Working Paper No. **HDH-09-08**
(9th HDH meeting, 21 to 23 March 2012)

9th Heavy Duty Hybrid (HDH) meeting 21-23 March 2012, JASIC Tokyo JP

Comments to suggested "Extended" HILS approach (TUV)

Proposal of an "extended - HILS-System"

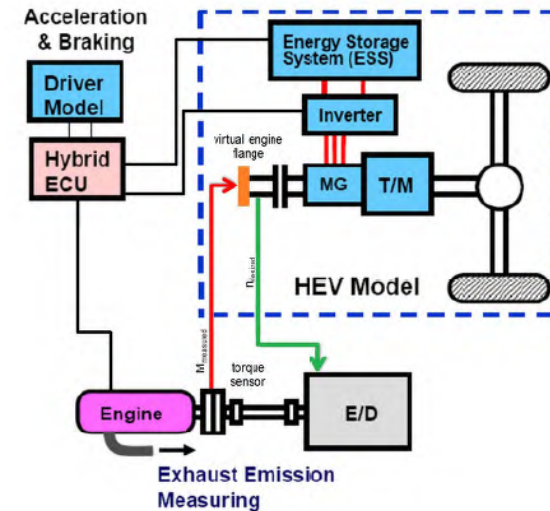
The arrangement will be advanced (equipment not commonly installed and connected to engine dyno).

The benefits will be low. Simple engine and thermal model during nominal conditions should be sufficient.

The preferable way to achieve higher grade of accuracy if necessary would be powerpack testing.

Extract from WHTC and WHVC from 1194 seconds

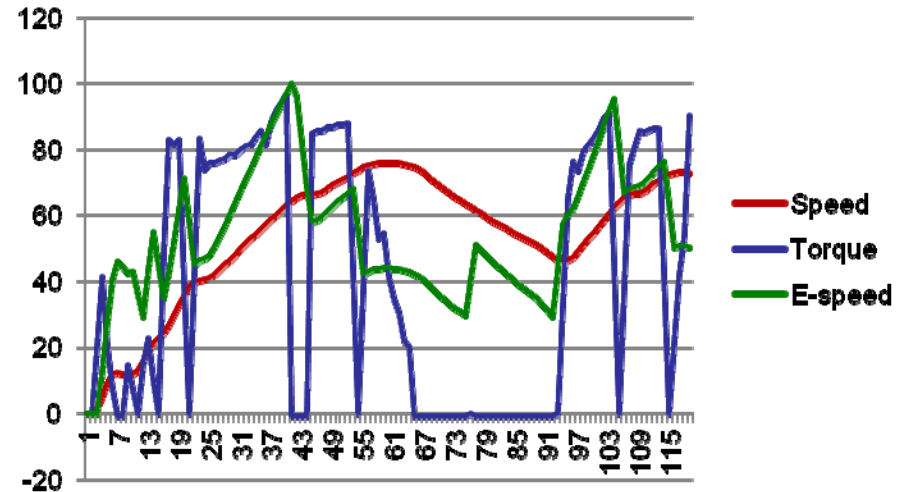
- WHDHC is based on WHTC
- WHTC is derived from WHVC based on a vehicle and driveline model with an average conventional gearbox
- By construction WHTC has artifacts, like gear shift torque interrupts, that may not be present in a hybrid vehicle with non-conventional gearbox
- WHTC is based on assumptions that may not be valid in future, for example: a serial hybrid.

No valid unit

Power

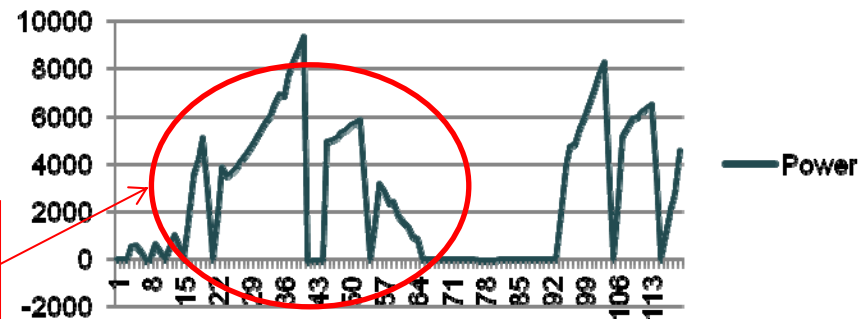
Power transients not representative for typical hybrid vehicle

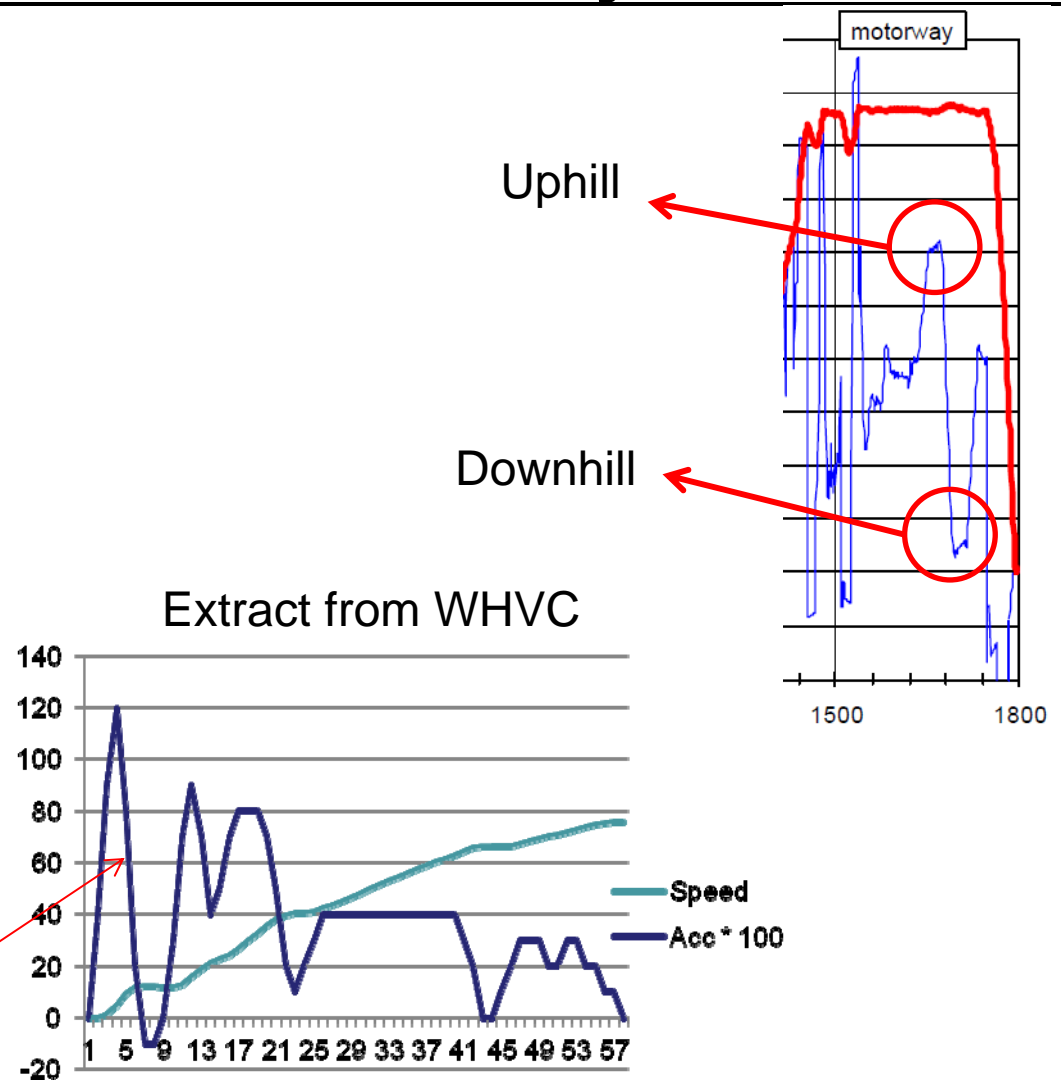
- Generic vehicle models needed for certification of product families
- WHVC defines no slopes (even though the derived WHTC clearly have some slopes in highway part). Without slopes the cycle is less representative for highway applications.
- Artifacts from conventional gearbox shifting visible in speed profile.

Significant jerk may come from traffic situation but more likely from gear shifts.
